# REQUIRED INSPECTION NOTICE

**DATE:** JULY 31, 1998  
**RIDE:** ONE TRUCK HIMALAYA  
**SUBJECT:** ROD END COUPLER THREADS  
**COMPLIANCE:** MANDATORY  
**COMPLETION DATE:** IMMEDIATELY

## SAFETY BULLETIN

# **SERVICE BULLETIN**

<b>WISDOM INDUSTRIES</b> Merino, CO 80741		
SCALE: NTS	APPROVED BY:	DRAWN BY: JLC
DATE: 7-19-96		REVISED
DESCRIPTION CAR HITCH		
EQUIPMENT: COASTERS		DRAWING NUMBER DWG #

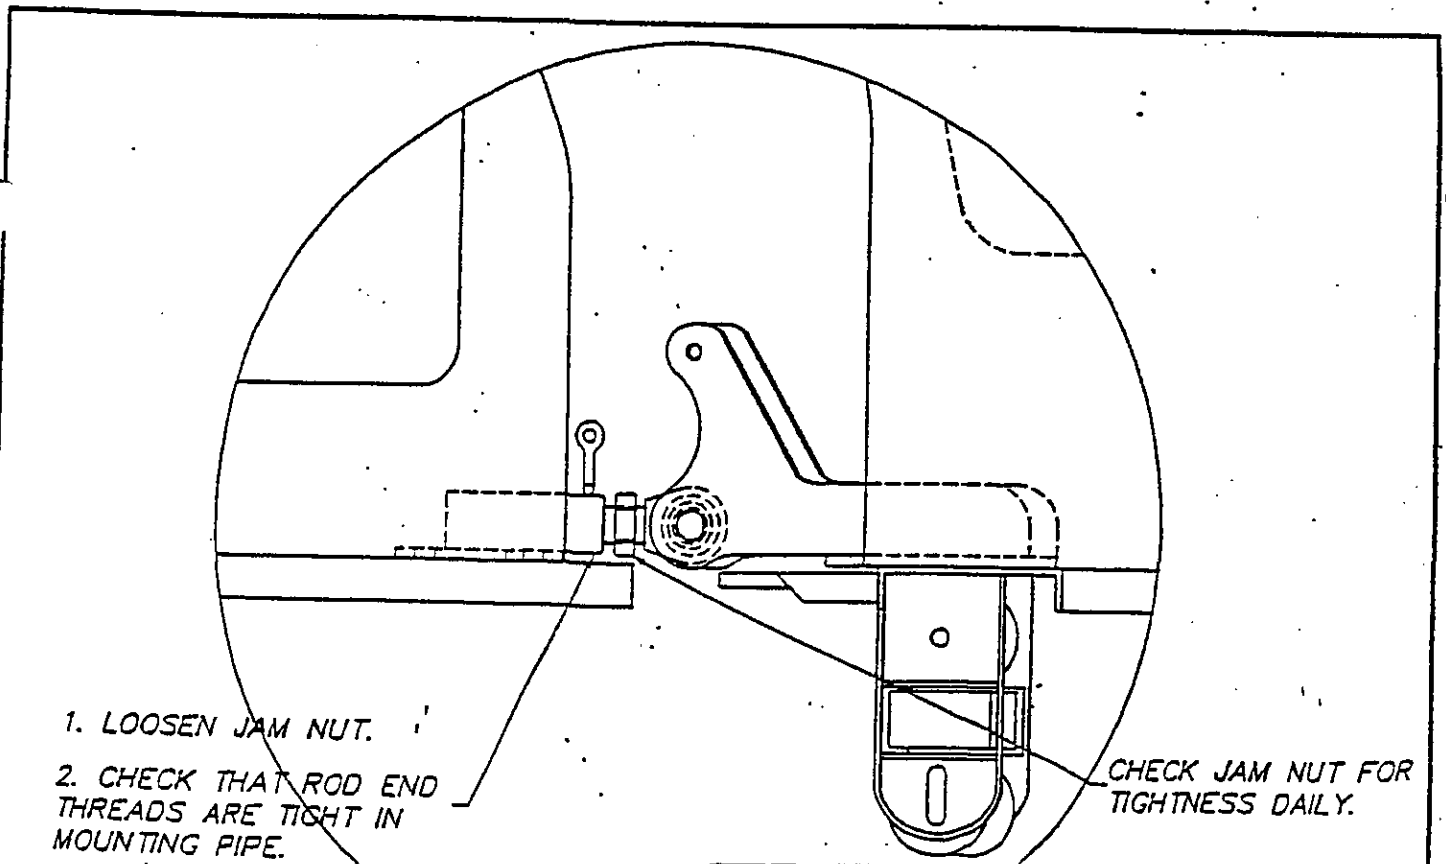
One coaster has experienced wear on the threads on the rod end connecting the cars together. The same connection is used on the Himalaya. The wear is caused by the lock nut loosening and allowing the rod end to work back and forth in the coupler mount. To prevent the possibility of the rod end pulling out of the mount, check the threads in all rod end couplers for wear and replace any that are worn.

1. Loosen jam nut on rod end.
2. Raise and lower the front of the car that the rod end is attached to.
3. Look for looseness or movement of the thread end inside the coupling mount as the front of the car is raised and lowered.
4. If no looseness is observed retighten the rod end.
5. If the threads are loose remove the rod end and replace.
6. Retighten the rod end.

1. LOOSEN JAM NUT.
2. CHECK THAT ROD END THREADS ARE TIGHT IN MOUNTING PIPE.
3. TIGHTEN JAM NUT.

CHECK JAM NUT FOR TIGHTNESS DAILY.

1. Block up front of car.
2. Remove connecting pin.
3. Push car ahead to allow access to rod end.
4. Loosen lock nut.
5. Unscrew rod end from coupler.
6. Screw lock nut from original rod end onto new rod end.

7. Screw new rod end into front of car.
8. Tighten lock nut.
9. Reconnect cars together with pin and R-key.
10. Check that the lock nut is tight.
11. Remove blocks and check track for objects on the track that can stop the ride.
12. Test run ride.
13. Check that the jam nut is tight daily.

<b>WISDOM INDUSTRIES</b> Merino, CO 80741		
SCALE: 3/8" = 1'-0"	APPROVED BY:	DRAWN BY: SAS
DATE: 12/18/98		REVISED
DESCRIPTION		
MAIN CAR SWEEP		
EQUIPMENT:	DRAWING NUMBER	
MID-SIZE HIMALAYA	MAIN_SWEEP

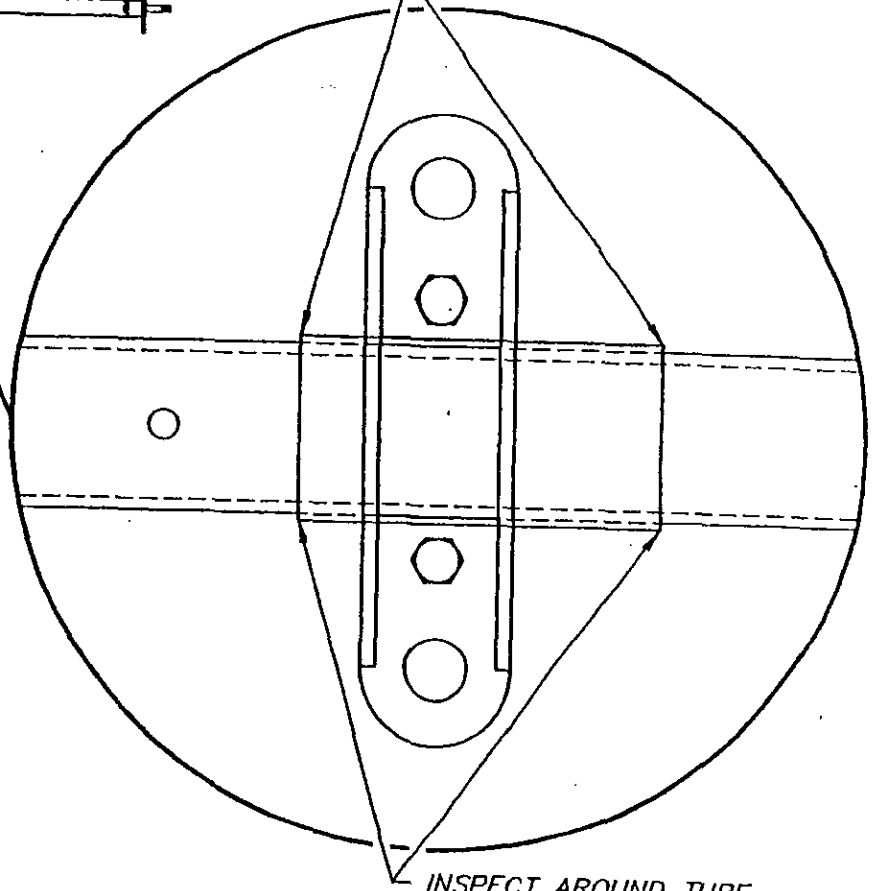
One Himalaya has experienced cracking on the master sweep where the diagonal rods pivot the end of the sleeve. Review the drawing on the reverse side and inspect for cracking around the tube at the end of the sleeve. If cracks are indicated contact Wisdom Industries at 800-634-6097 for repair or replacement of the sweep.

INSPECT AROUND TUBE

INSPECT MAIN SWEEP TUBE FOR CRACKS.  
 CLEAN OFF GREASE & DIRT BEFORE INSPECTING.  
 IF CRACKS ARE FOUND, DO NOT OPERATE  
 THE RIDE UNTIL CONTACTING WISDOM INDUSTRIES  
 AT (800) 634-6097 FOR REPAIR OR REPLACEMENT  
 INSTRUCTIONS.  
 USE VISUAL INSPECTION FOLLOWED BY MAGNA FLUX.

1. Clean area on each master sweep where indicated on the drawing.
2. Visually inspect around the circumference for cracks.
3. Follow the visual inspection with magnaflux.
4. If cracks are found contact Wisdom Industries before operating the ride for instructions on repair or replacement of the sweep.
5. Repeat for the other 3 master sweeps.

<b>WISDOM INDUSTRIES</b> Merino, CO 80741	
SCALE: 3/4" = 1'-0"	APPROVED BY:		
DATE: 04/06/99		DRAWN BY: CKW	
DESCRIPTION		REVISED	
<b>CAR HITCH SERVICE BULLETIN</b>			
EQUIPMENT:		DRAWING NUMBER	
<b>HIMALAYA</b>		<b>BH 099</b>

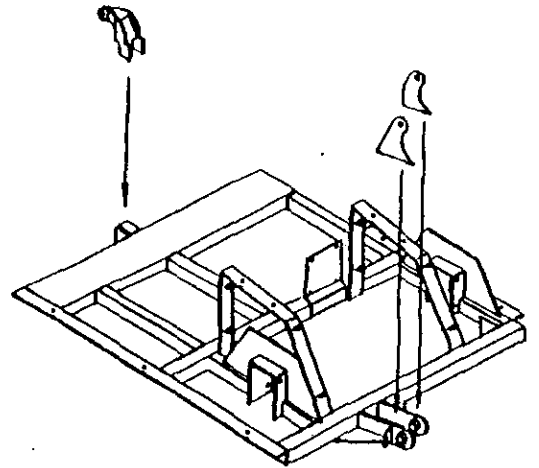
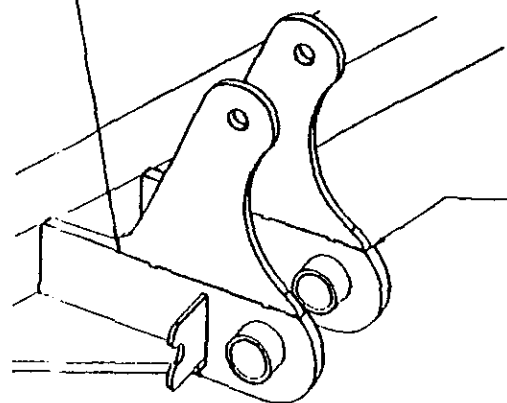
Install the safety plates and couplers between the cars according to the drawing shown on the reverse. Contact Wisdom Industries for a set of plates to install.

Until the safety plates are installed, check the jam nut between the cars daily for tightness. If a jam nut is found to be loose. Remove the rod end and check the threads for wear. Replace the rod end if the threads are worn on the rod ends.

BE SURE HOLES LINE UP BEFORE WELDING

NOTE 1: BE SURE BOTTOM OF BRACKET IS PARALLEL WITH TUBING TO ACHIEVE CORRECT HOLE HEIGHT.

NOTE 2: ALIGN FRONT CORNERS BEFORE WELDING.

<b>WISDOM INDUSTRIES</b> Merino, CO 80741		
SCALE: 3/8" = 1'-0"	APPROVED BY:	DRAWN BY: SAS
DATE: 12/18/98		REVISED
DESCRIPTION		
CAR SWEEP		
EQUIPMENT:	DRAWING NUMBER	
MID-SIZE HIMALAYA	CAR_SWEEP

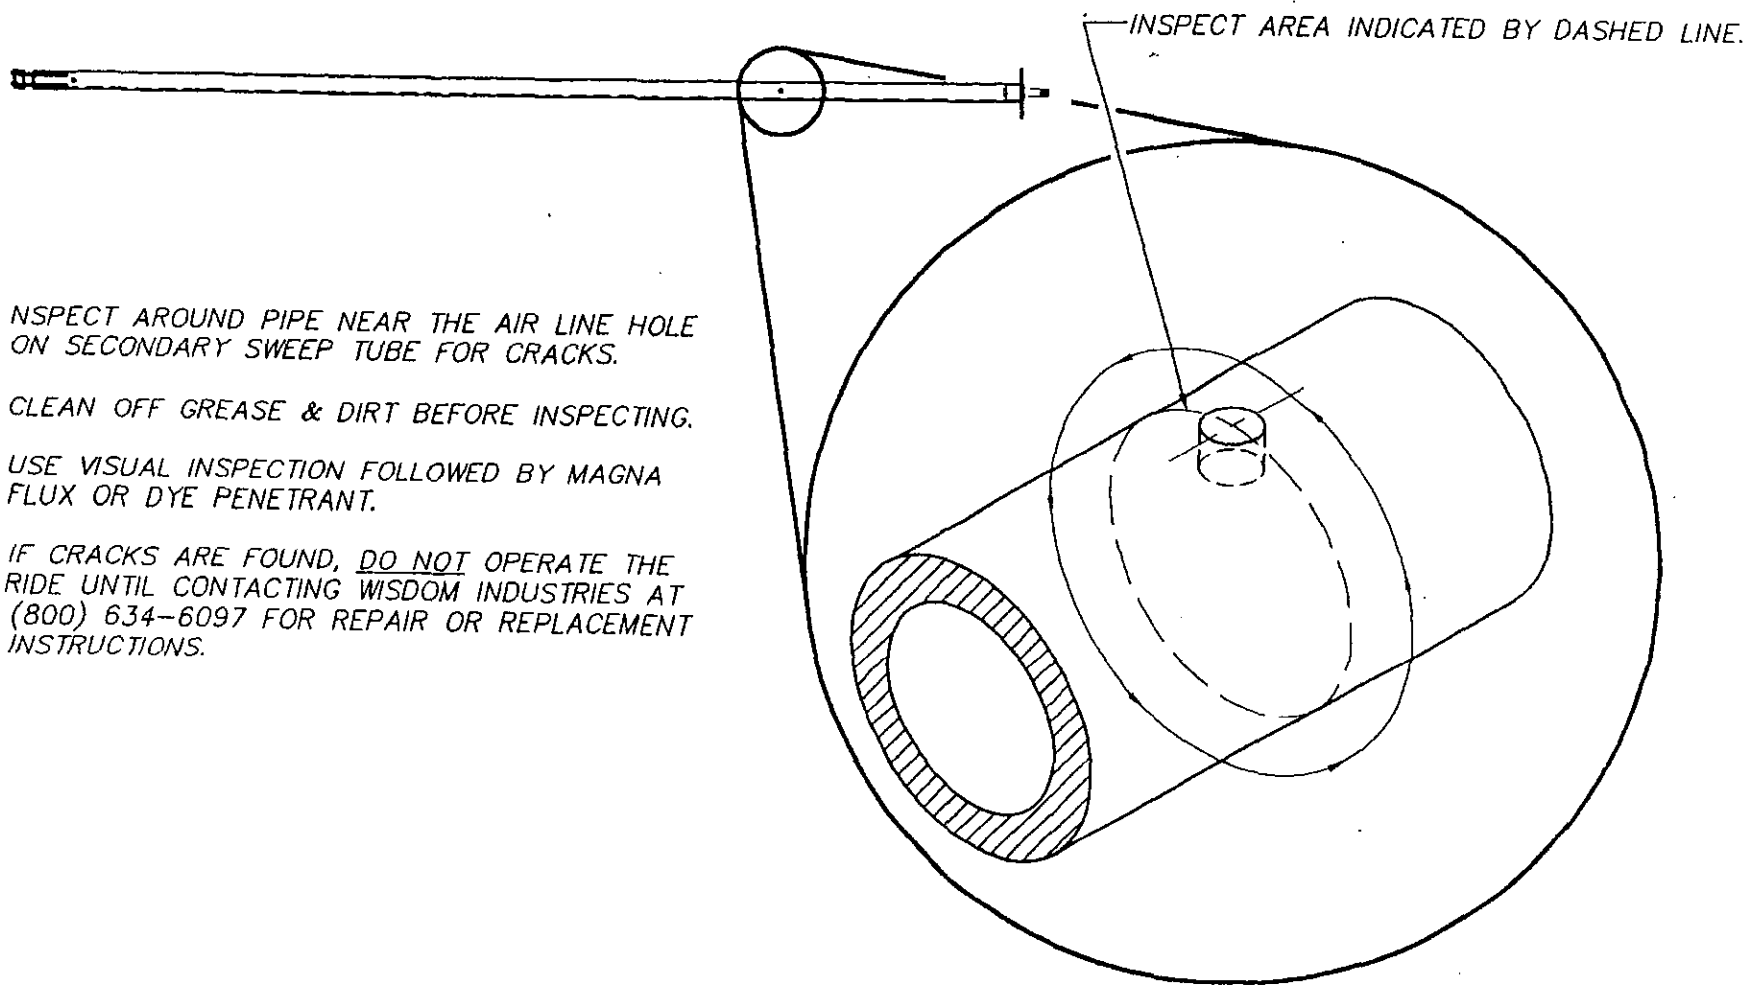
One Himalaya has experienced cracking on the secondary sweeps where the air line hole is drilled near the cars. Review the drawing on the reverse side and inspect for cracking around the airline hole. If cracks are indicated contact Wisdom Industries at 800-634-6097 for repair or replacement of the sweep.

INSPECT AROUND PIPE NEAR THE AIR LINE HOLE ON SECONDARY SWEEP TUBE FOR CRACKS.

IF CRACKS ARE FOUND, DO NOT OPERATE THE RIDE UNTIL CONTACTING WISDOM INDUSTRIES AT (800) 634-6097 FOR REPAIR OR REPLACEMENT INSTRUCTIONS.

1. Clean area on each secondary sweep where the air line exits the pipe ( see drawing).
2. Visually inspect around the circumference of the pipe at the air line hole for cracks.
3. Follow the visual inspection with magnaflex or dye penetrant.
4. If cracks are found contact Wisdom Industries before operating the ride for instructions on repair or replacement of the sweep.
5. Repeat for the other 17 secondary sweeps.

HANDLEBAR SOLUTION

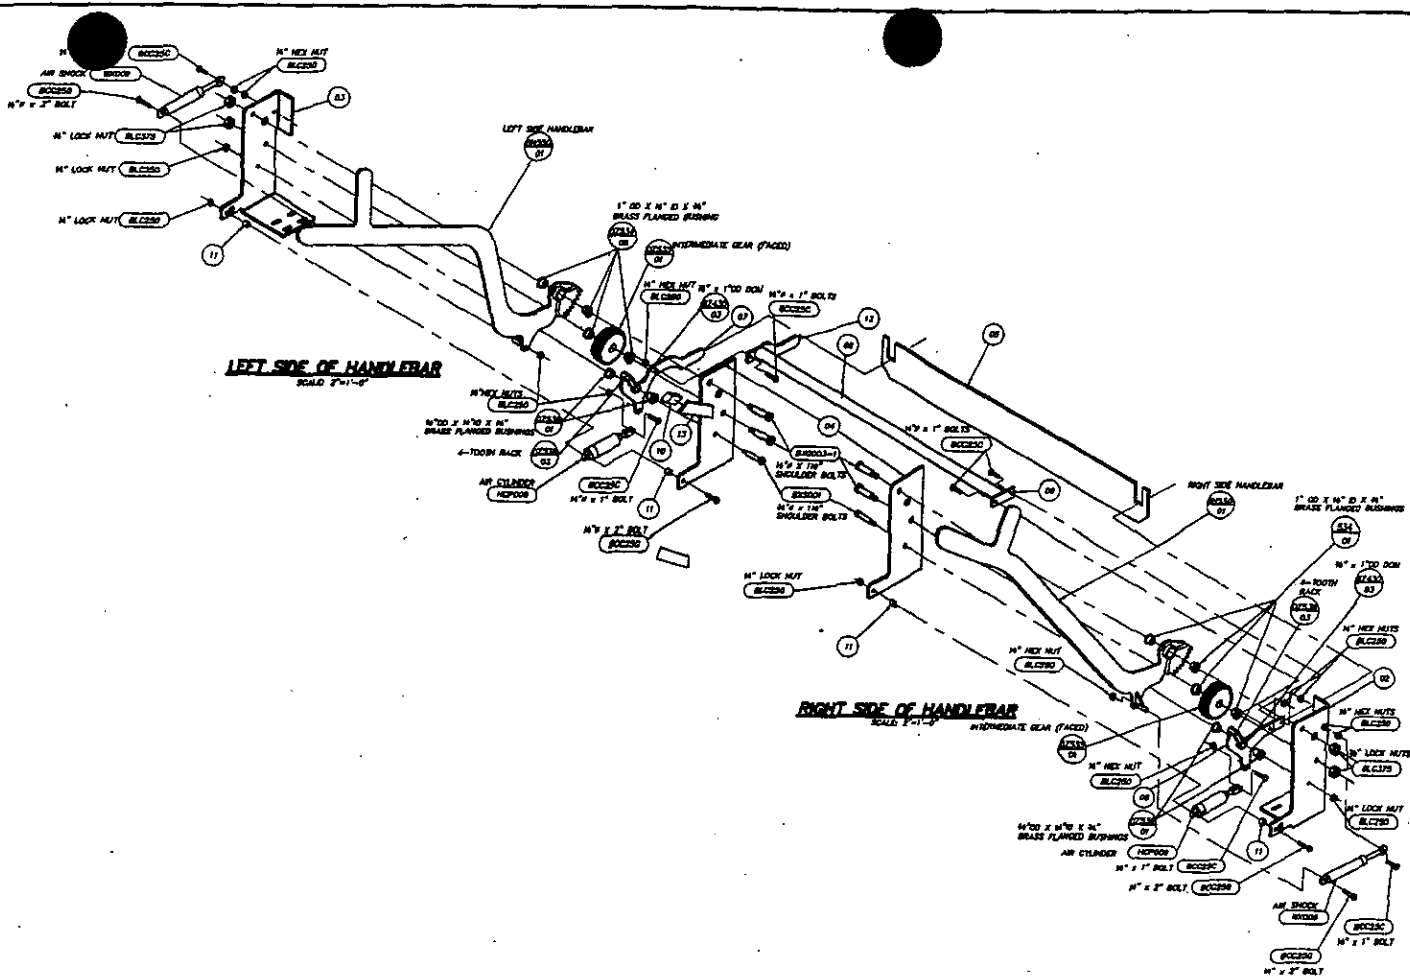
IT HAS COME TO OUR ATTENTION THAT ON A FEW OF THE MID-SIZED HIMALAYA'S THE INSIDE HANDLEBAR LOCKING MECHANISM MAY BE HITTING THE FIBERGLASS BODY OF THE CAR. THIS MAY NOT ALLOW THE HANDLE BAR TO LATCH PROPERLY.

INSPECT YOUR HANDLEBARS, AND IF THIS PROBLEM EXISTS DRILL AN 1-1/4" TO 1-1/2" HOLE, USING A HOLE SAW, IN THE BODY OF THE CAR AT THE LOCATION OF THE INTERFERENCE. THIS CAN BE DONE EASILY FROM THE OUT SIDE OF THE CAR UPON SET UP OR TEARDOWN OF THE RIDE.

- 1. Review the enclosed drawing to locate a 1 ¼ hole to be cut in the fiberglass.**
- 2. Check that hole is in the correct location to keep the lock dog from hitting the car body.**
- 3. Perform latch check to see that the inside lock dog engages completely.**
- 4. Perform the same operation on the remaining 21 cars.**
